## ADDENDUM

Date Issued:	Sep 19, 2025
Project:	Intermountain Health Layton Hospital - Mammography 201 W Layton Pkwy, Layton, UT 84041
Addendum Number:	1

**ADDENDUM #1****DATE:** September 19, 2025**PROJECT NO:** 250580**PROJECT:** Intermountain Layton Hospital Mammography Remodel

## Electrical Addendum #1

LEVEL 1 HVAC  
DEMO AND  
NEW PLANS

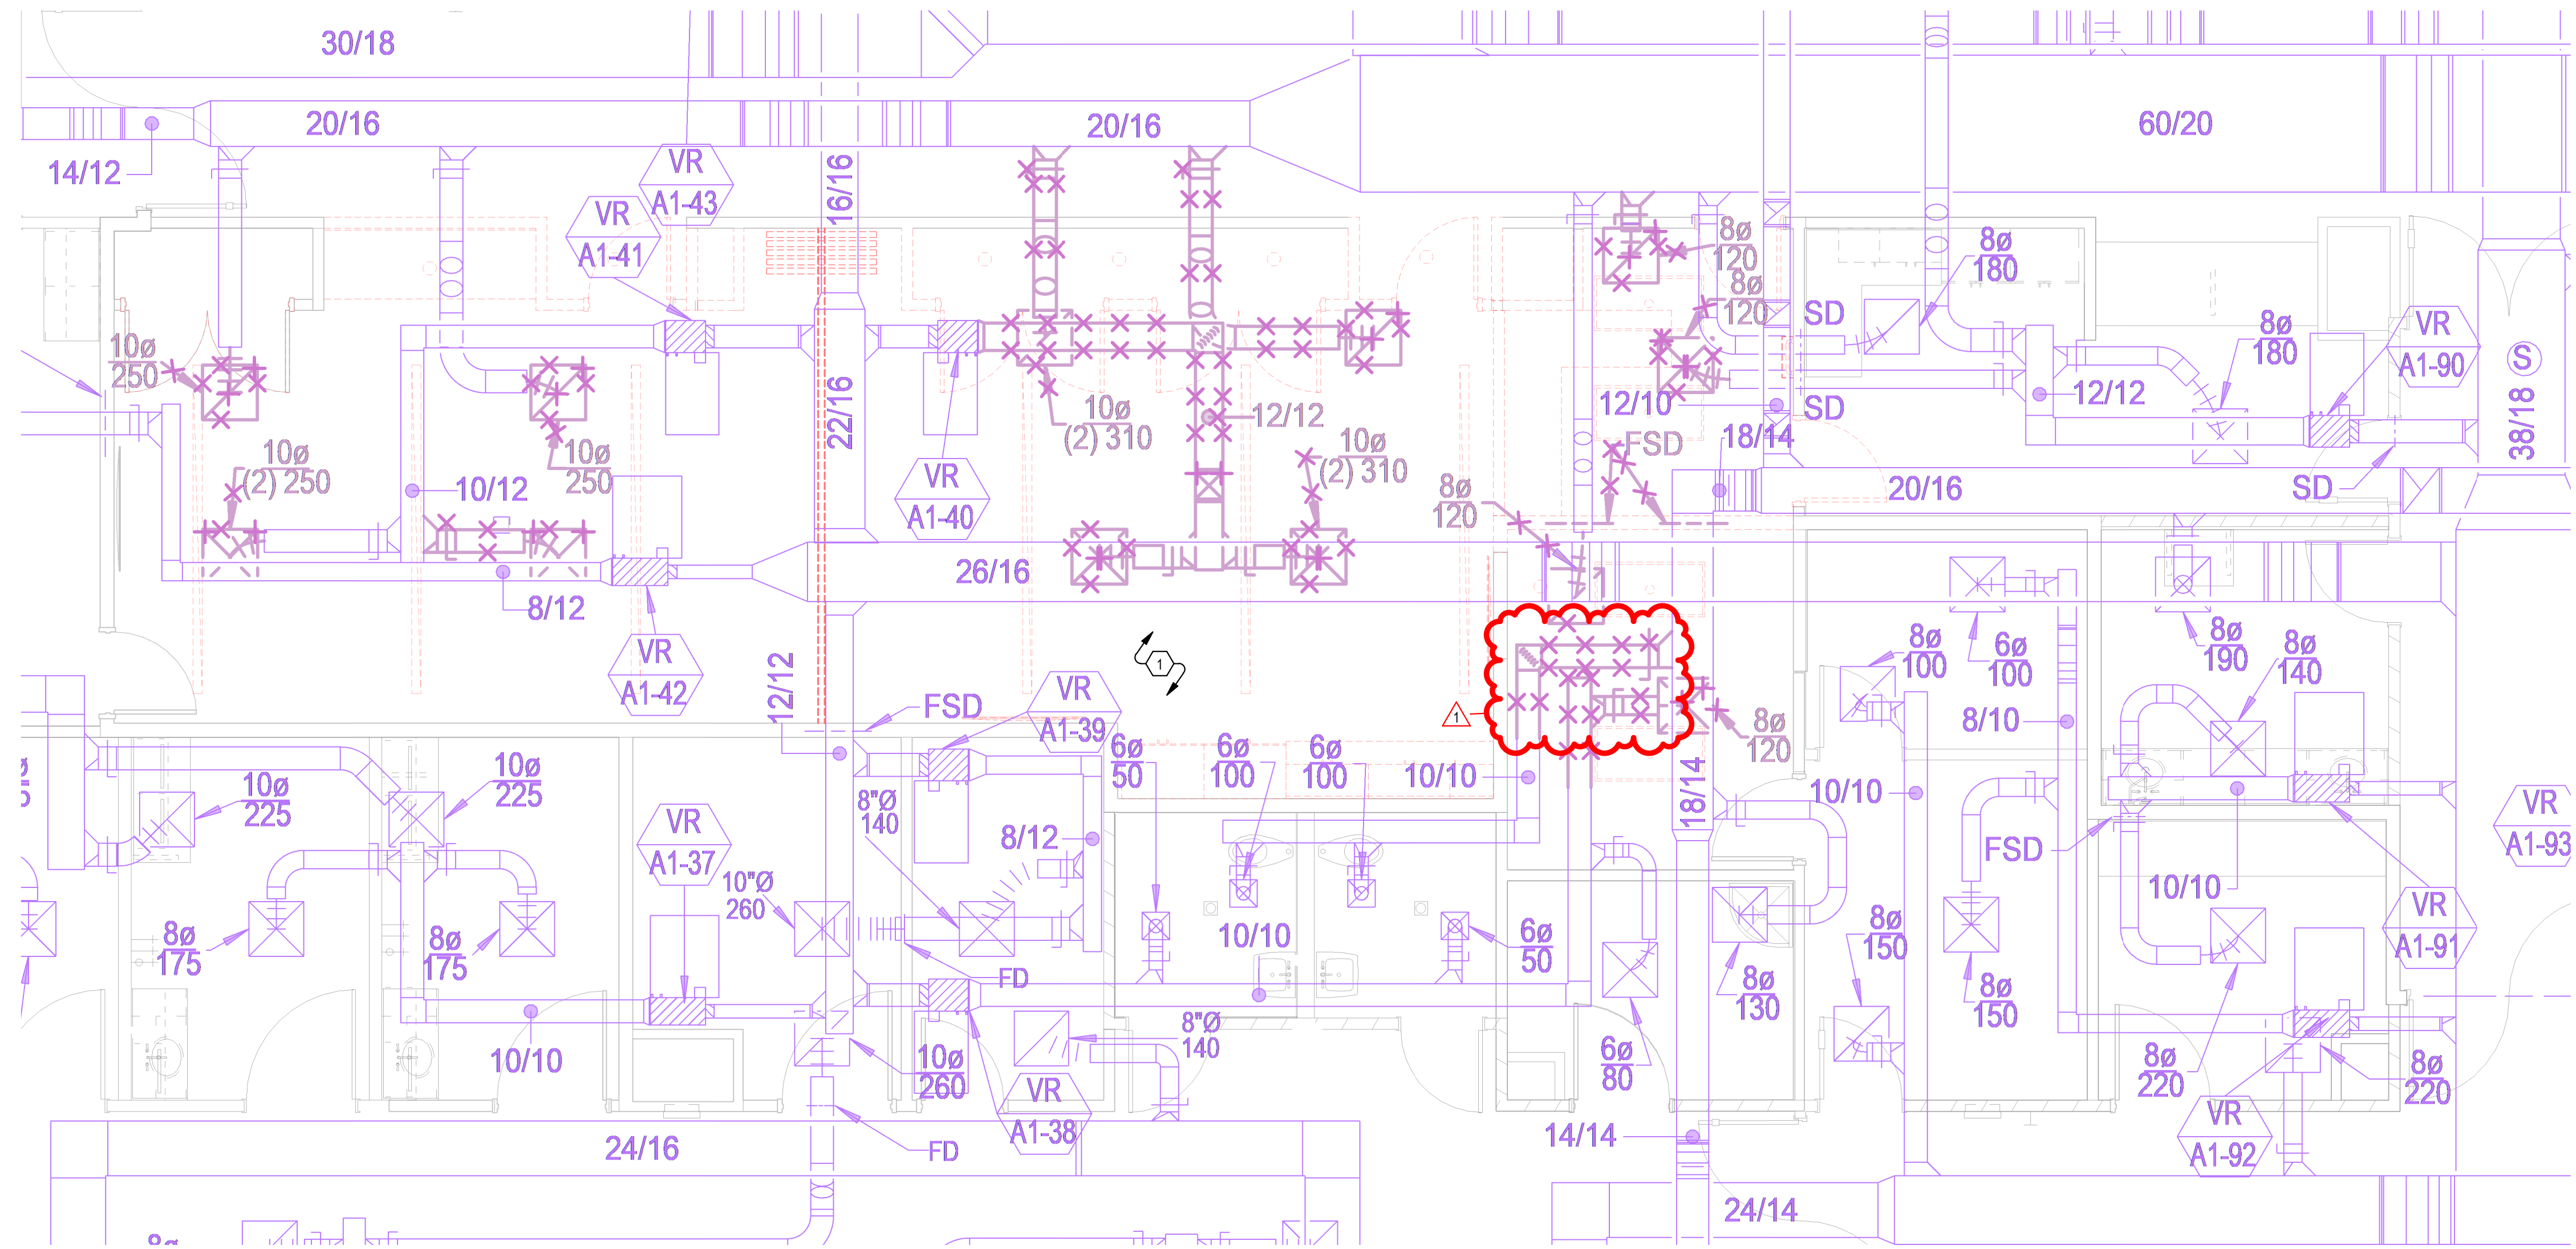
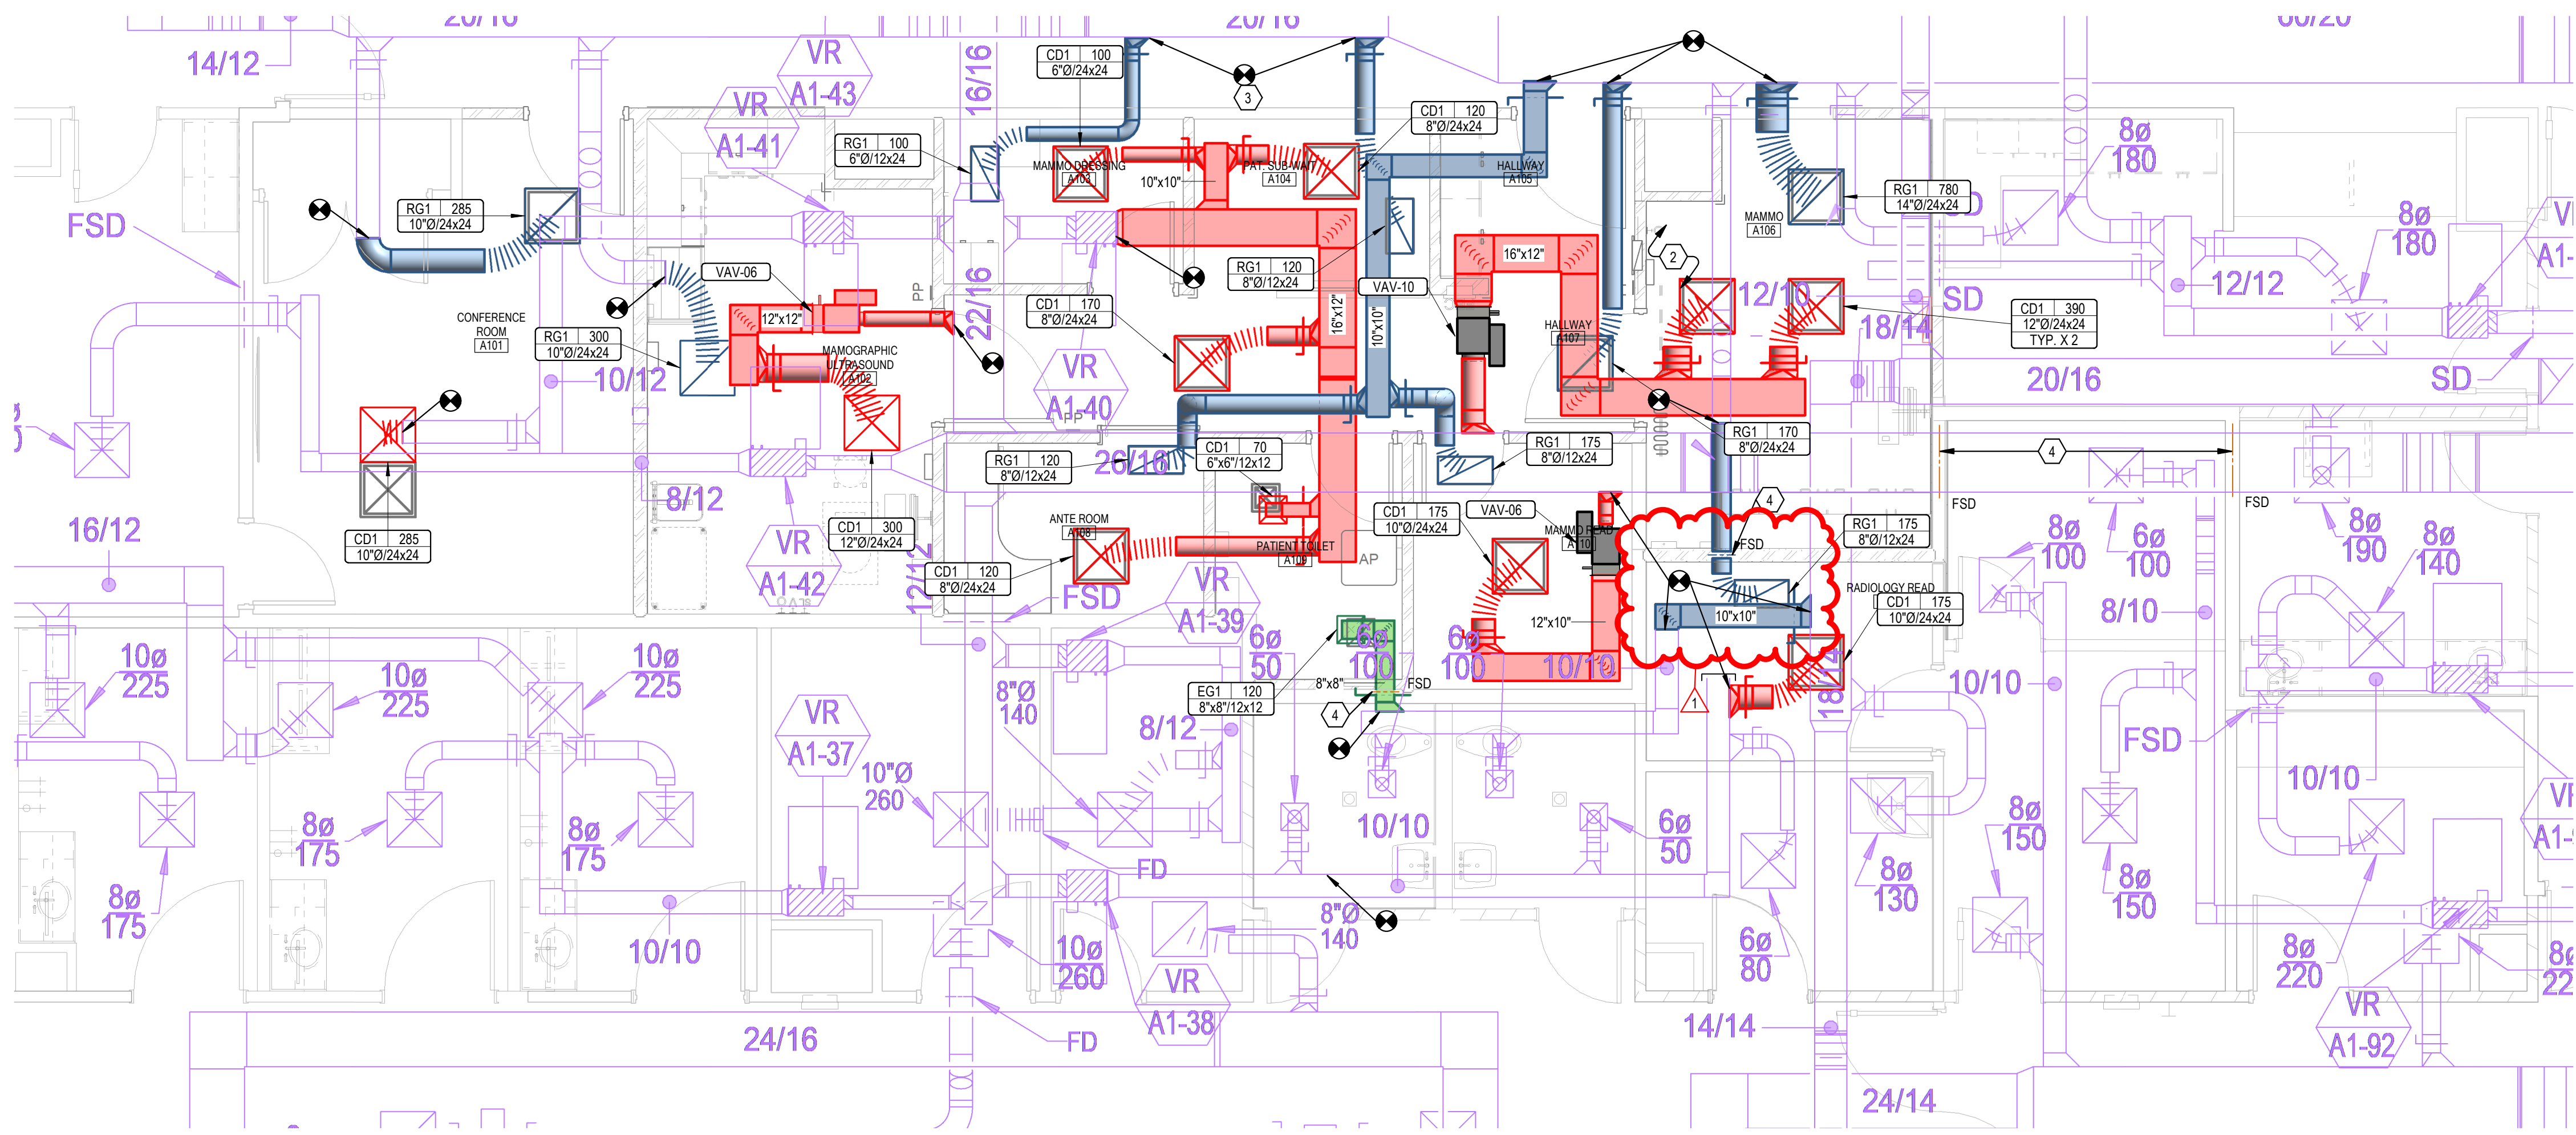
**DIVISION – 21,22,23,26****DRAWINGS****SHEET - M101**

1. Relocated existing exhaust located above wall between Mammography room and Rad Reading room to eliminate the need for a fire smoke damper.

LEVEL 1  
AUXILIARY  
PLAN

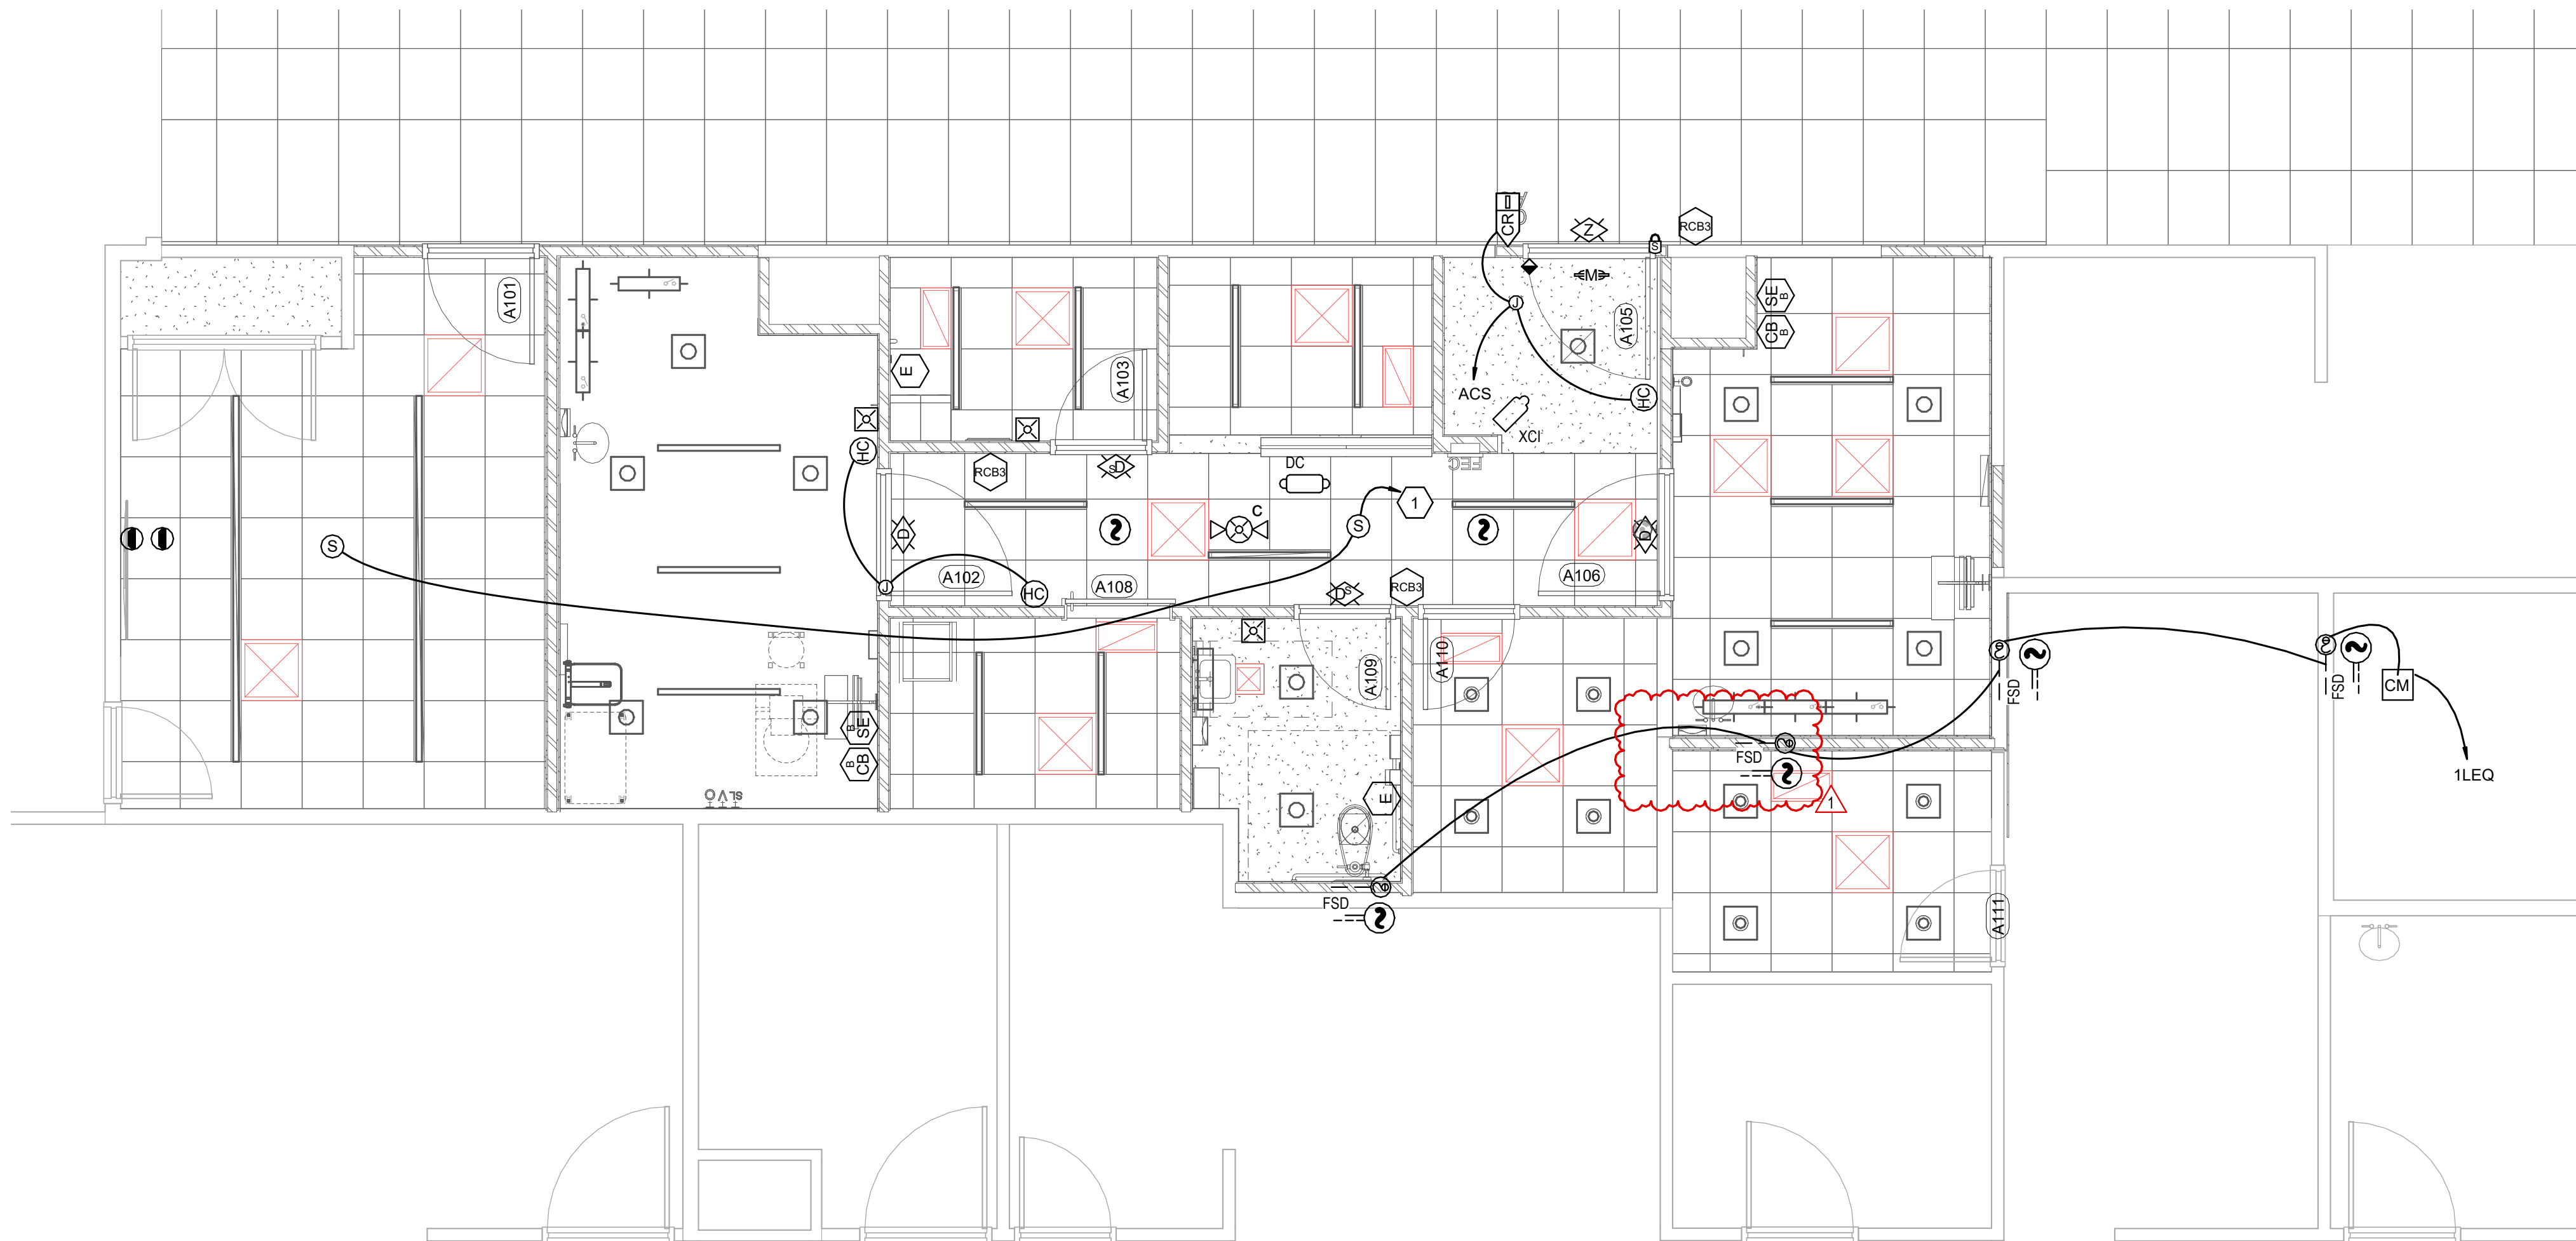
1. EL601 – Interior Lighting Fixture Schedule
  - a. Added more approved manufacturers to the lighting fixture schedule.
2. EY101 – Level 1 Auxiliary Plan
  - a. Removed one smoke damper to match the mechanical plans.
